**RE: Environmental Protection Agency, Environmental Impact Statements; Notice of Availability; EIS No. 20240024, Draft Supplement, BR, UT, Glen Canyon Dam Long-Term Experimental and Management Plan – 89 FR 28, February 9, 2024**

## Attachment 1 Draft SEIS Detailed Comments

**Figure 1: Relative risk of resource insufficiency in the Desert Southwest throughout the day**

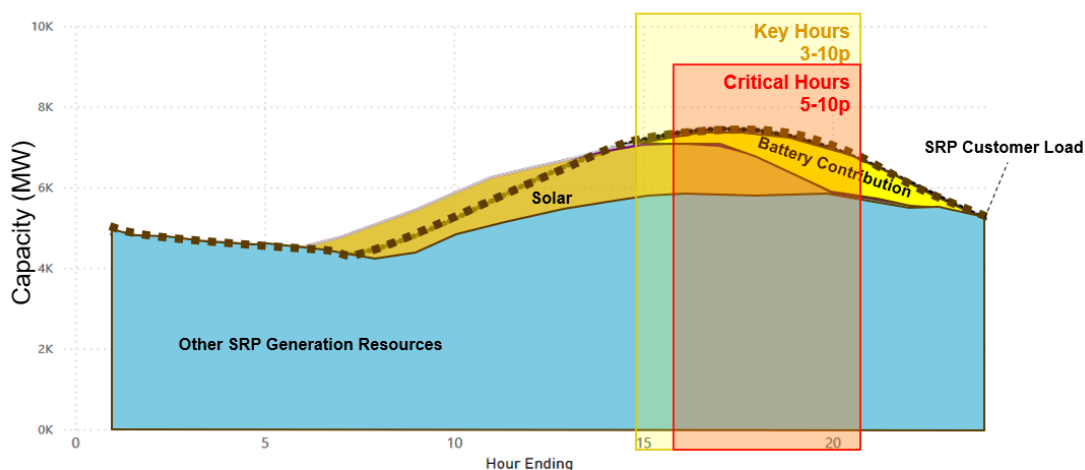
One of the most significant impacts of the DSEIS’s proposed alternatives is the hydropower generation capacity reductions anticipated during the most reliability-sensitive times of the year for the desert southwest region. Reliable power is critical to human health and safety during summers in the Phoenix area—where temperatures exceeded 110 degrees *every day* of July 2023, for example. Most of the reliability risk that SRP and other desert southwest utilities manage occurs from 3pm to 10pm over summer months when ambient temperatures are peaking, demand is at its highest and solar production is waning or no longer available (see Figure 1). Despite considerable mitigation efforts, these hours will continue to drive most of the risk.

The risk to SRP’s reliability is driven by available capacity from 3-10pm (HE15-HE22):

- Peak Load Hours, Limited Available Capacity
- Solar contribution maximizes then drops off rapidly
